Service Bulletin

Bulletin No.: 21-NA-046

Subject: Loss of Window Motor Memory – Window Drops Down

Brand:	Model:	Model Year:		VIN:		Engine:	Transmission:
		from	to	from	to		
GMC	Terrain	2018	2021			All	All
Chevrolet	Equinox		2020				
Holden	Equinox

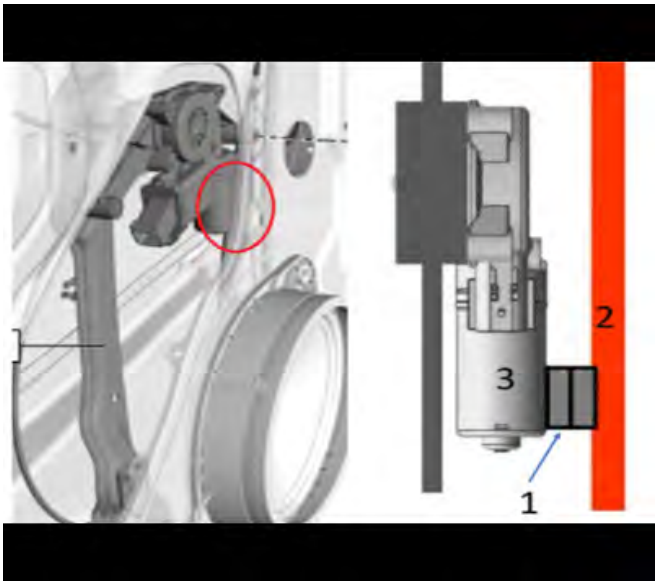
Note: In the graphic above, the foam is shown in the correct location on the motor housing, but will be applied to the inner door panel, not the motor housing.

4. Make sure the inside of the inner door panel is clean, then adhere the foam (1) to the inside of the inner door panel (2), mounting it between the end of the motor housing (3) and inner door panel (2).

3. Cut dense, adhesive backed, closed cell foam (Kent Automotive P/N 83327 or equivalent) to reach a 12 mm (1/2") thickness and 25 mm (1") square. In this example, there are 2-6 mm x 25 mm x 25 mm (1/4" x 1" x 1") squares adhered together.
